Flatbread Grill
2 North Forest Beach Drive, #101
Roof Addition
October 22, 2024
DRB-001353-2024

Flatbread Grill
2 North Forest Beach Drive, #101
Roof Addition
Narrative
October 22 2024
DRB-001353-2024

DESIGN TEAM/DRB COMMENT SHEET

AD101

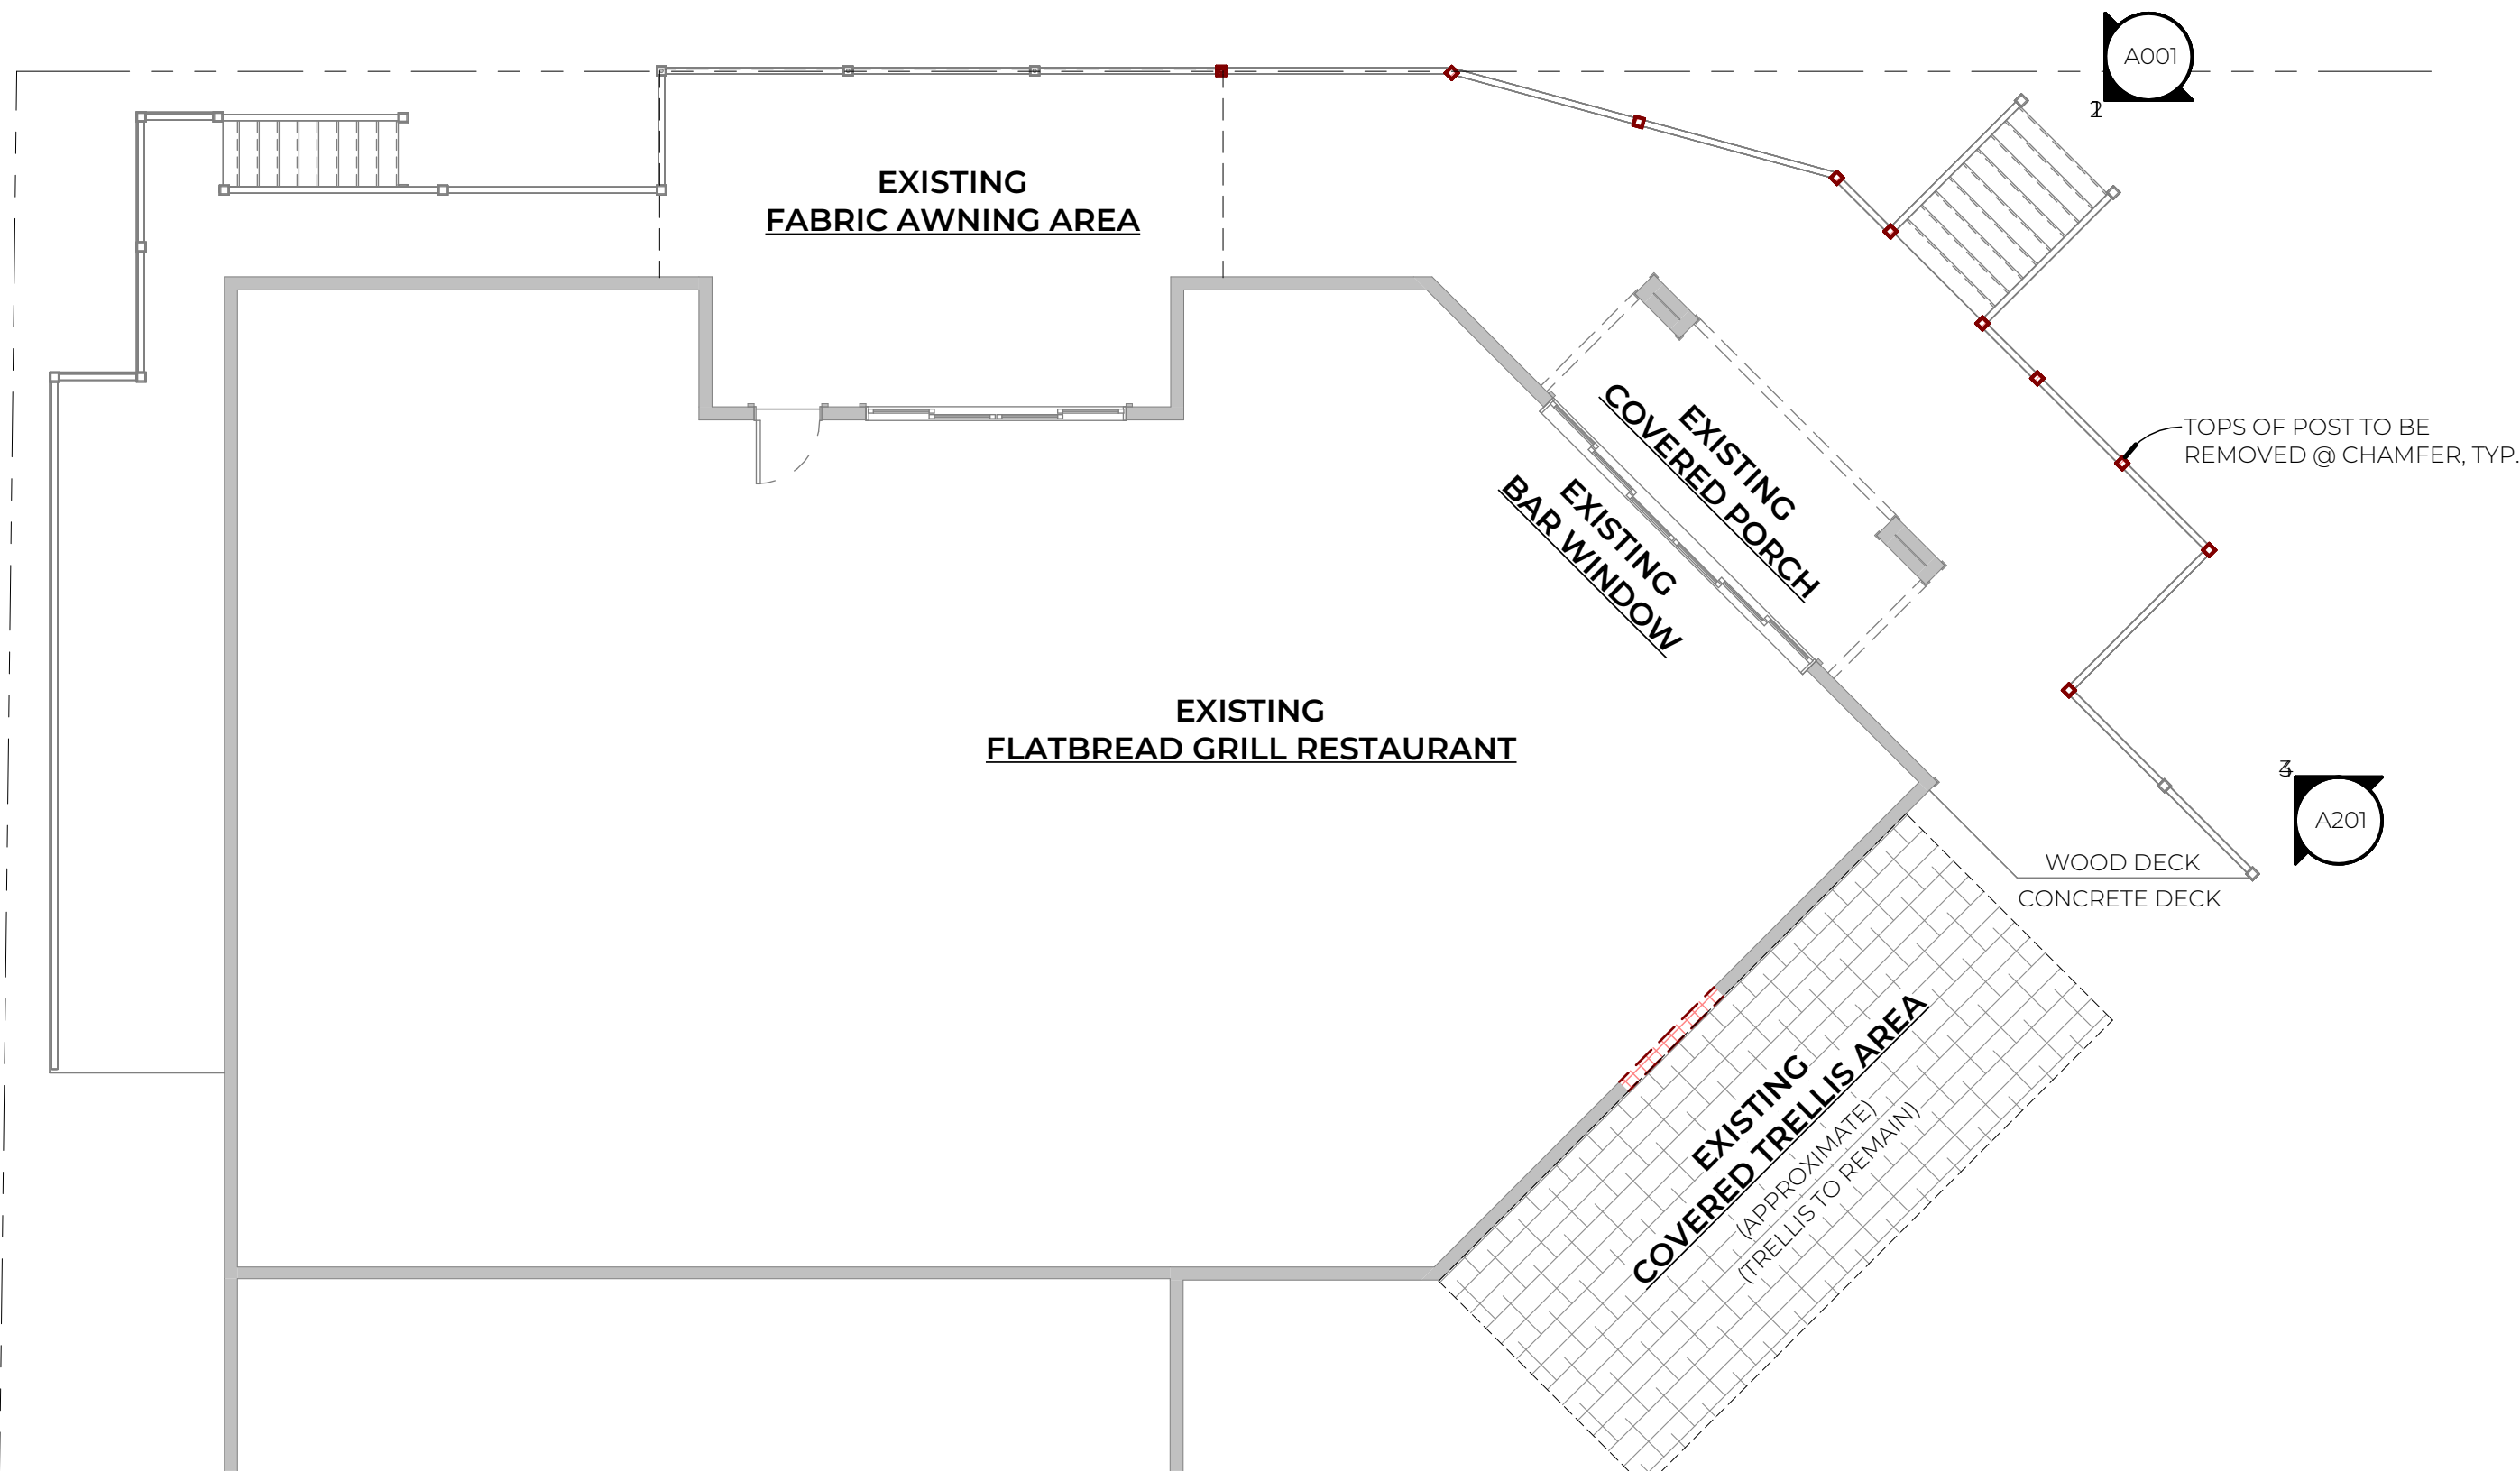
DRB REQUIREMENTS	Complies Yes	No	Not Applicable	Comments or Conditions
Demolition Plan if needed	☒	☐	☐	
Existing Conditions match As-Built	☐	☒	☐	There is a section of roofing that was never approved or received building permits for that is not part of this proposal yet part of the roof plan. This area should be address as well as the proposed roof addition.
Dimensioned Details and of Sections	☒	☐	☐	
Detail Illustrating Connection to Existing Structure	☒	☐	☐	
New Building Details Match Existing Building Details	☒	☐	☐
